Subject: Calvert Cliffs Nuclear Power Plant
Units Nos. 1 & 2; Dockets Nos. 50-317 and 50-318
Safety Parameter Display System (SPDS)

RESPONSE TO NRC 10/23/84
REQUEST FOR ADDITIONAL INFORMATION
CONCERNING THE
CALVERT CLIFFS 1 & 2
SAFETY PARAMETER DISPLAY SYSTEM

DATA ACQUISITION SYSTEM (TYPICAL CHANNEL)

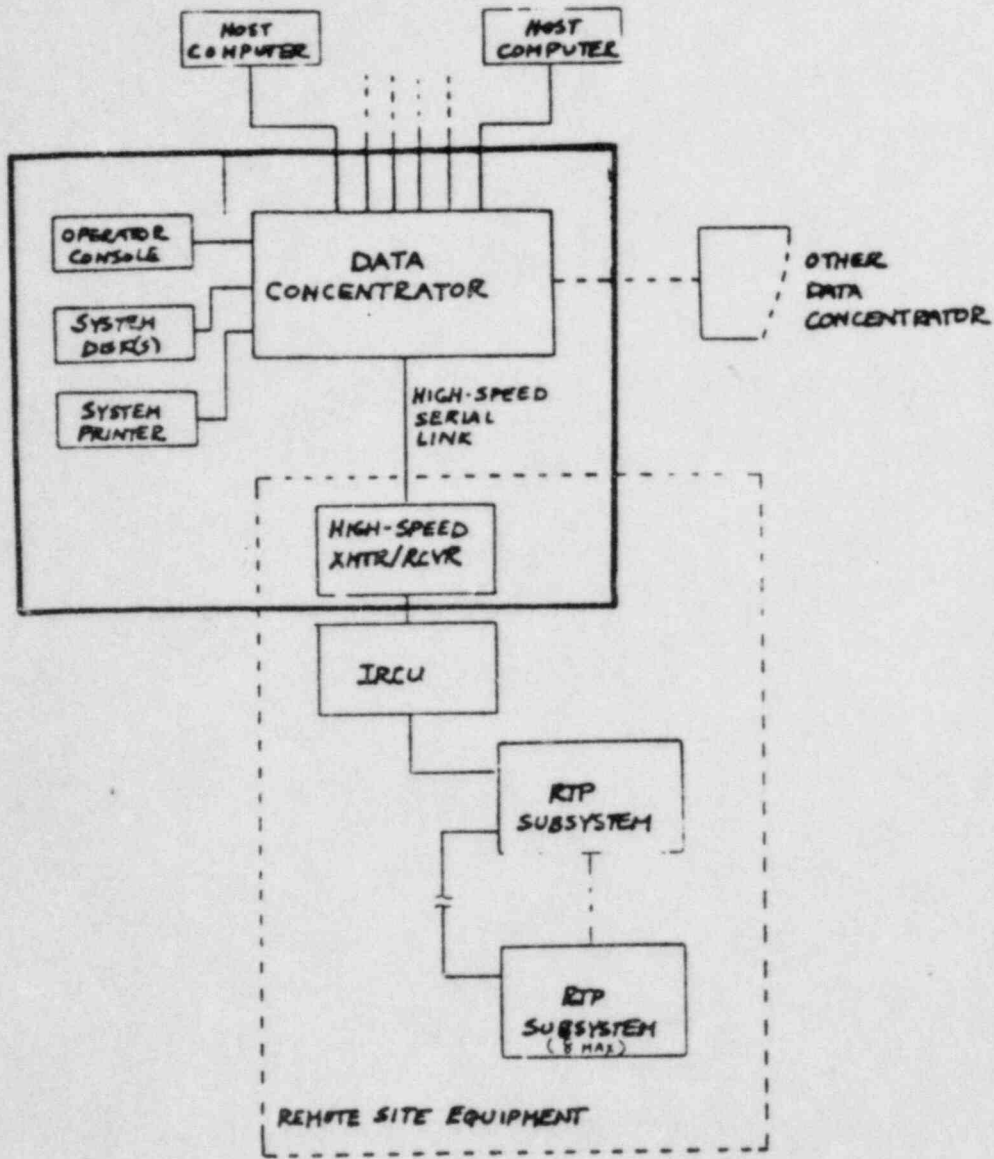
- a. For each type of device used to accomplish electrical isolation, describe the specific testing performed to demonstrate that the device is acceptable for its application(s). This description should include elementary diagrams when necessary to indicate the test configuration and how the maximum credible faults were applied to the devices.

- b. Data to verify that the maximum credible faults applied during the test were the maximum voltage/current to which the device could be exposed, and define how the maximum voltage/current was determined.

- c. Data to verify that the maximum credible fault was applied to the output of the device in the transverse mode (between signal and return) and other faults were considered (i.e., open and short circuits).

- a. The Data Acquisition System (DAS) provides electrical isolation between the non-safety related SPDS and the plant's safety-related instrumentation systems. The DAS is designed such that a fault associated with any input or output will not affect any other input or output. A block diagram of one channel of the DAS is provided as Attachment 1. The devices within the dotted box comprise the remote I/O cabinets. The inputs are instrument loops and the output is a high speed serial link via fiber-optic cable. The inputs are isolated with various modules selected for the specific signal type. A copy of the test procedure for these isolation modules is provided as Attachment 2 (Remote I/O Equipment Hardware Acceptance Test Procedure for NUS Corp./Baltimore Gas and Electric Company, Calvert Cliffs Data Acquisition System, dated February 2, 1984).

- b. Maximum design withstand voltage is 600V sustained and 1250V surge per IEEE Std. 472. Calvert Cliffs electrical circuit and raceway design criteria insures separation between circuits such that input cables are not routed with cables for circuits above 500V rating.

- c. Output is via fiber-optic link.
- d. Modules were tested to ensure no change of output data and no change in functionality due to the surge test. The test procedure and acceptance critiera are described in Attachment 2 (for example, see sections 9.6, 10.7, and 10.13 for the optically isolated digital input module test process).
